NOTICE UNDER SECTION 96 (1) CHAPTER IX OF THE BOMBAY
DISTRICT MUNICIPAL ACT III OF 1901 AS MODIFIED
UPTO THE 1st MARCH 1915.

Case No. P/C 230 of 1932.Applicant's Name Sachy Jyot. Amil coop. H. SocietyArchitect's Name M/s. B.B. Adani & Co.Plot No. 36/9 Sheet No. J. M. 3, J. Amshu. Quarter

PLAN
SHOWING PROPOSED BUNGALOW
ON PLOT NO. 36 SHEET NO. J.M.3
FOR
THE HYDERABADI AMIL CO-OPERATIVE
HOUSING SOCIETY
SCALE 8"=1"

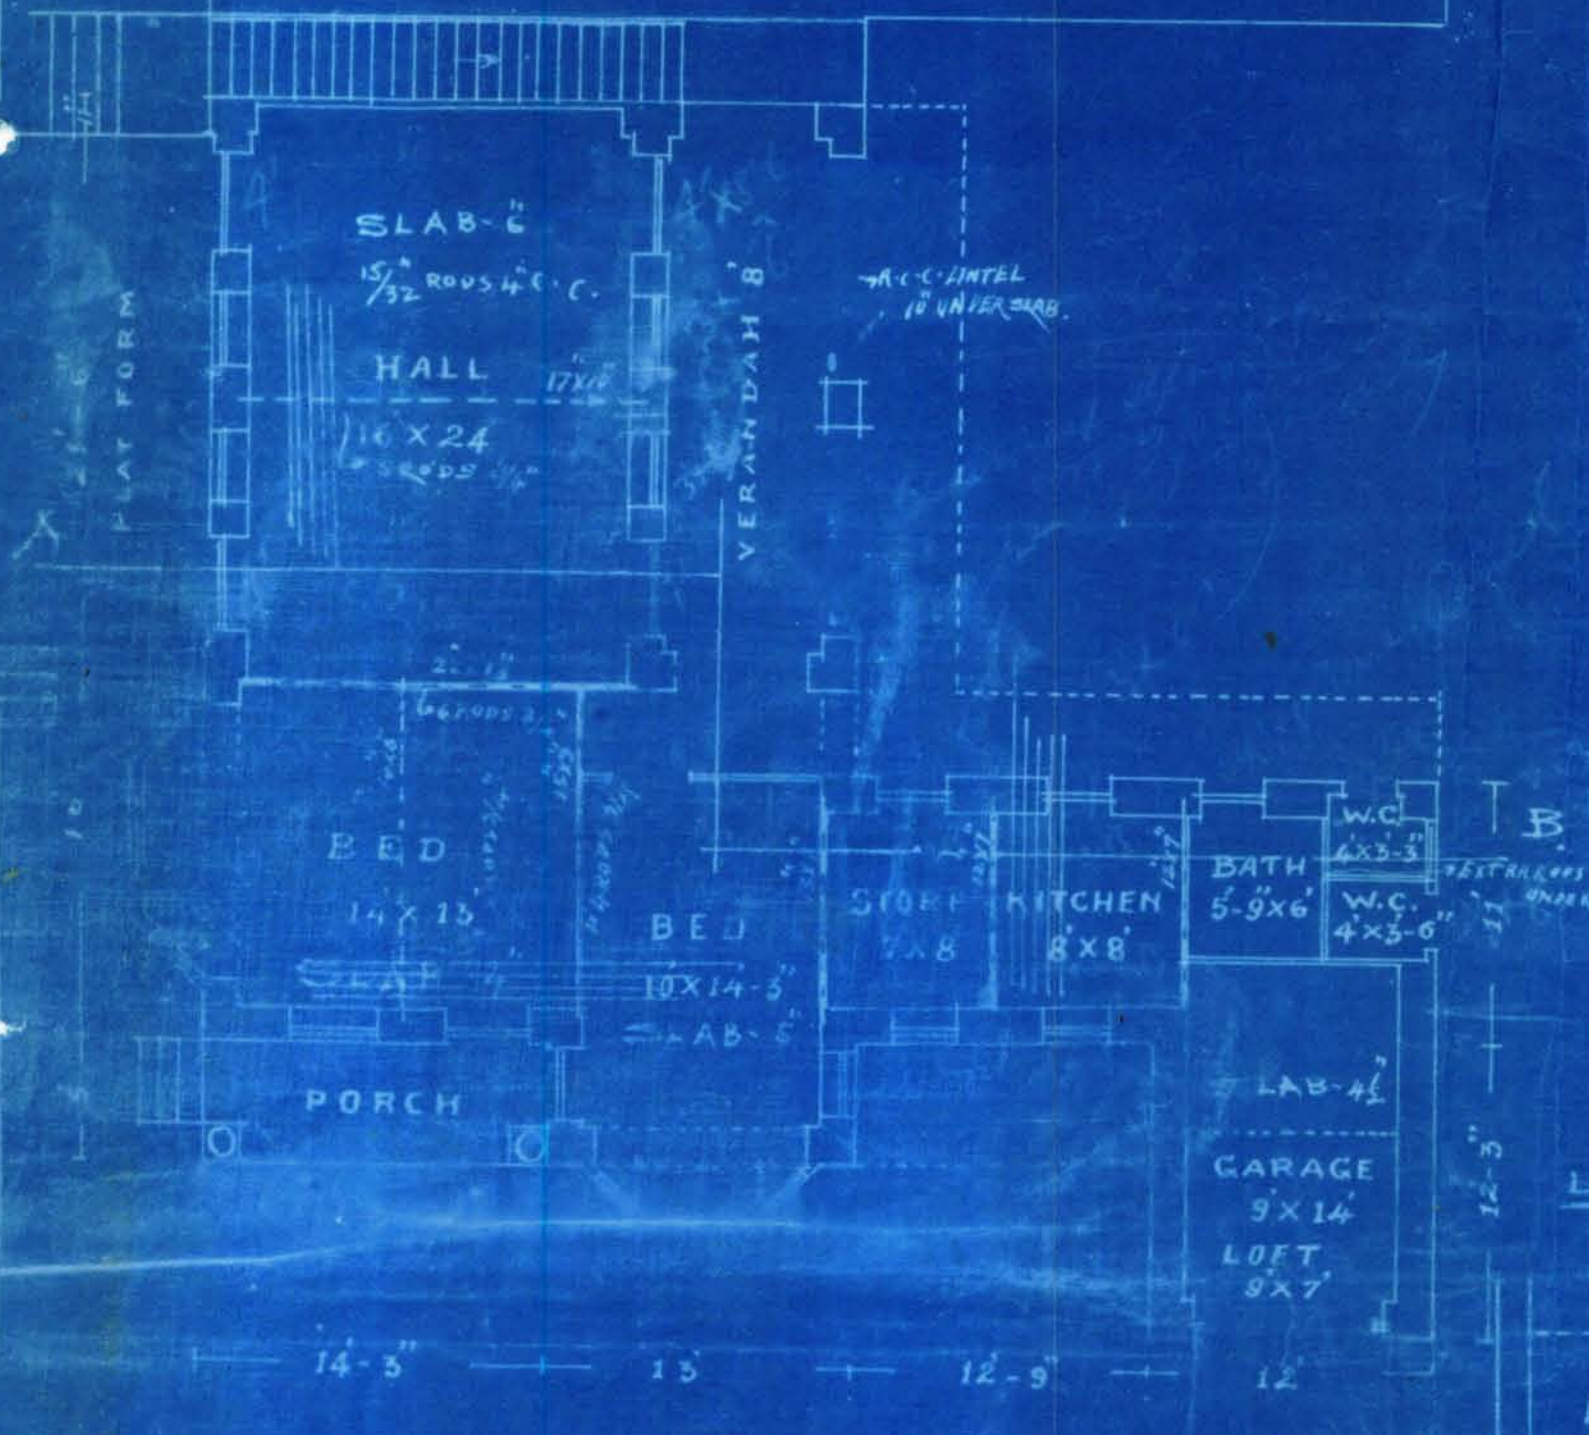
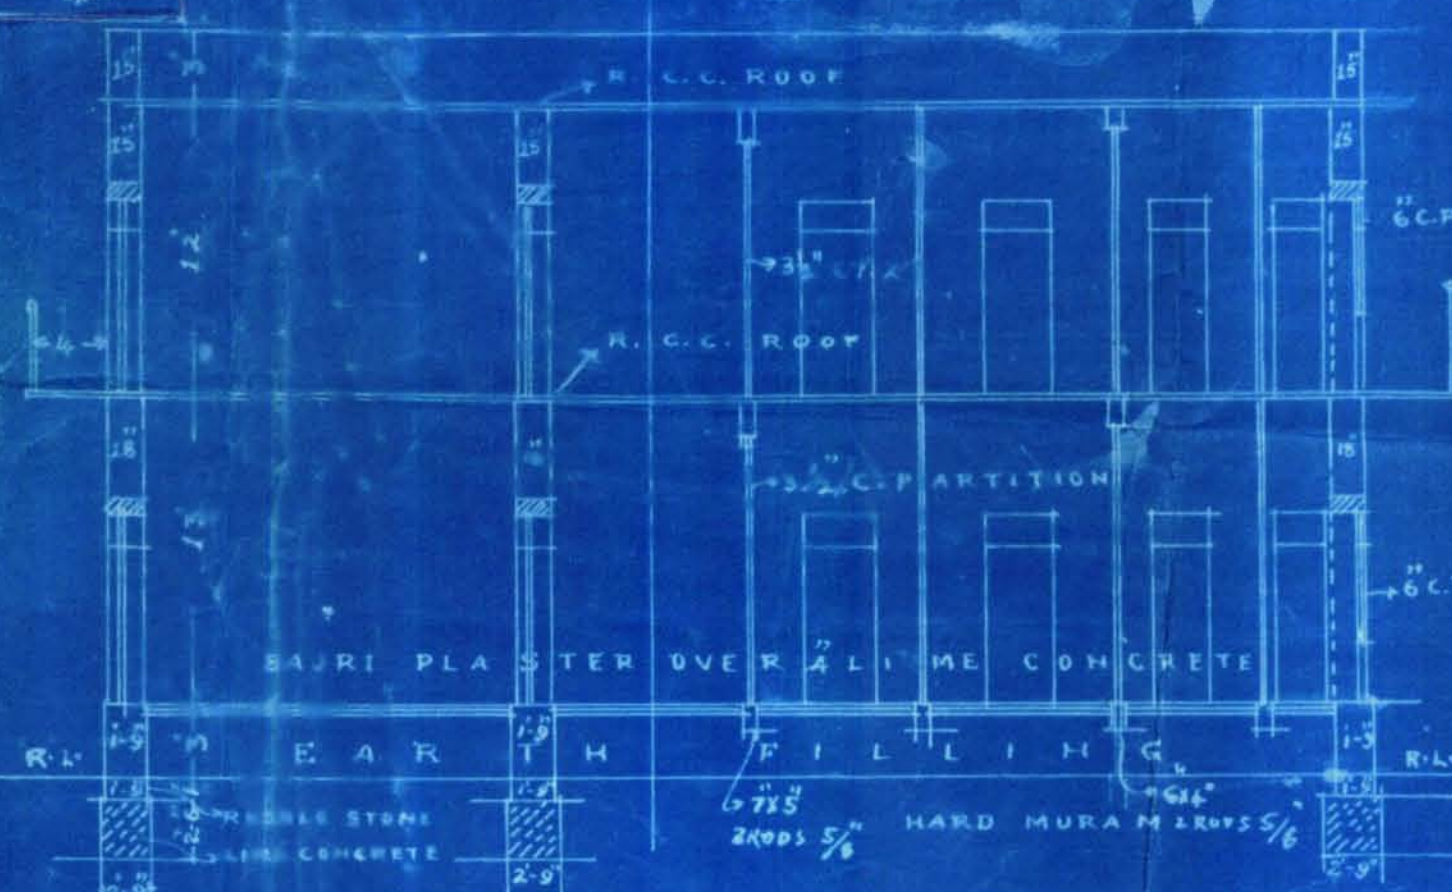
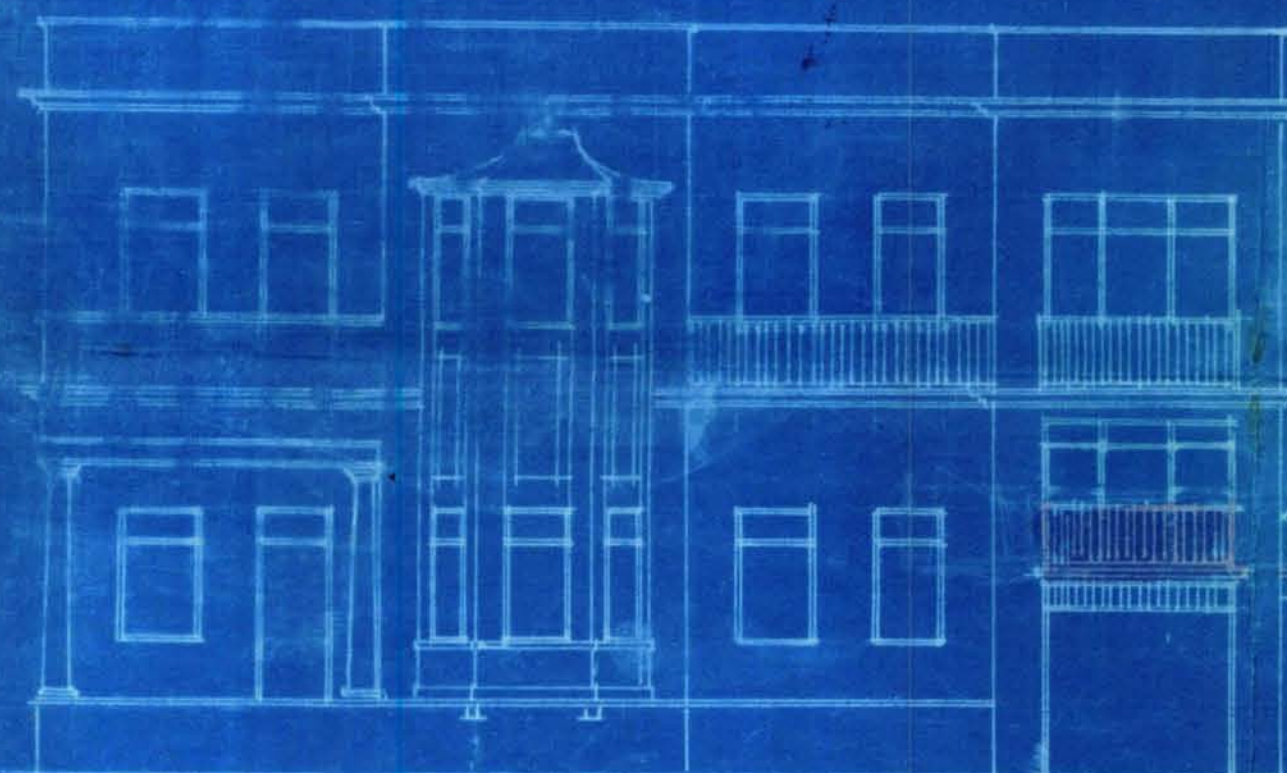
- ① A clear blue prints are required.
- ② Continuous galleries. ^{corn} Porch must be added in built up area.
- ③ Back A must be added to built up area.
- ④ Plans will be passed if the ^{to} area is within $\frac{1}{4}$. 1918.

- I have to request you to comply with the following requirements:—
- ✓ (1) Clear false prints are required.
 - ✓ (2) Continuous gallery is covered porch must be included in built up area.
 - ✓ (3) Bath A must be added to built up area.
 - ✓ (4) Plan will be passed if the area is within $\frac{1}{4}$.
 - (5)

== PLAN ==
-- SHOWING PROPOSED BUNGALOW --
-- ON PLOT No. 36 SHEET No. J.M.3 --
== FOR ==
THE HYDERABADI AMIL CO-OPERATIVE
-- HOUSING SOCIETY --
-- SCALE 8" = 1" --

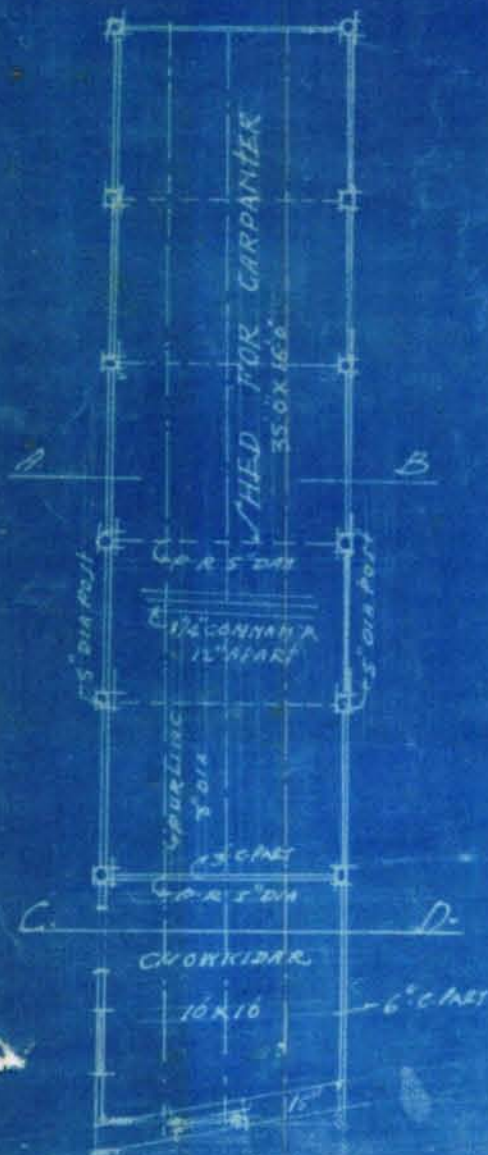
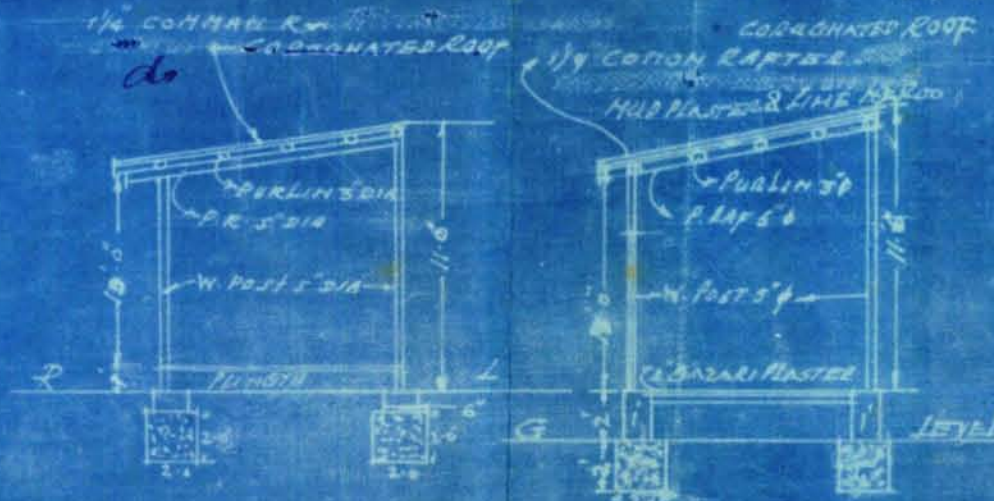
1. Put up approval form and
thapa. have a written
form that " Bay window on 1st
floor cannot be allowed. Only balcony
will be allowed -

note - Bay Window on 1st floor cannot be allowed, only balconies will be allowed.
